TWR-KL25Z Tower Module

Revision C ERRATA
TWR-KL25Z-ERRATA

Rev. 1.1

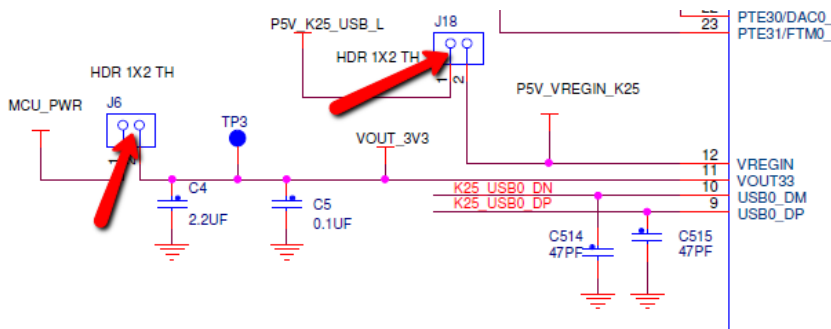
The usage of level shifters in the communication between the integrated debugger (OpenSDA) and the target MCU (KL25) is needed because the OpenSDA debugger runs at 3.3 volts while the KL25 can run at 3.3 or 1.8 volts. One of the level shifters that is used in the circuit is configured for a fixed direction of communication, which means that when not in use by the OpenSDA, the pin is kept in a fixed state. This fixed state inhibits external debuggers to work when the OpenSDA is powered (by connecting the mini USB connector).

The problematic signal is highlighted below.

To avoid the OpenSDA keeping this signal fixed so that an external debugger can be used, the OpenSDA needs to be unpowered. There are two available ways to power the board without powering the OpenSDA:

- Power through elevators: use the tower elevators and power the board through them.
- Stand-alone through the micro USB: the TWR-KL25Z includes a micro USB connector that is connected to the USB port in the KL25 device. The power input from this USB port is connected to the internal KL25 USB regulator and this regulator output can be routed to power the board by placing to jumpers (J6 and J18) in

1.2 Reset button

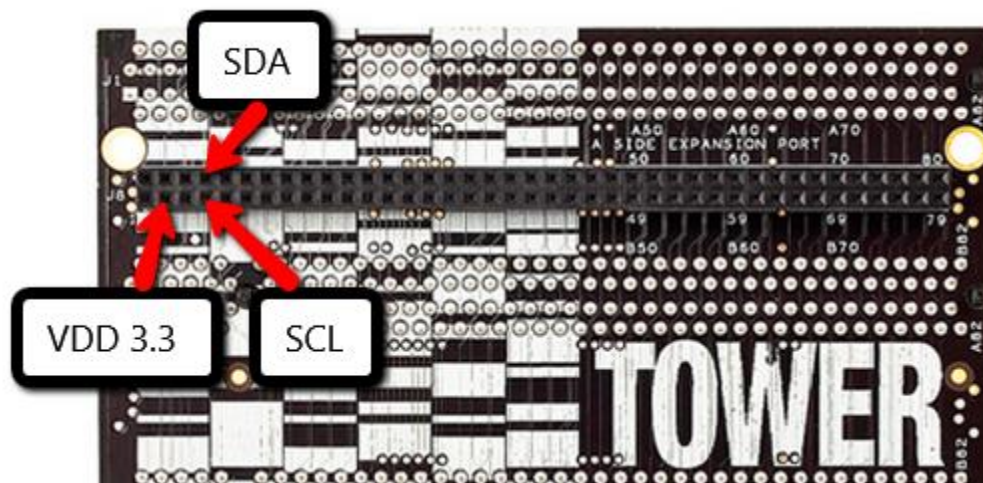
When the OpenSDA is not powered the reset button does not work. This is because the reset button has been placed in the OpenSDA side of the level shifter for the reset signal.

To be able to use the reset button, it is needed to power the OpenSDA circuit. This issue does not inhibit the POR or the external debugger reset.
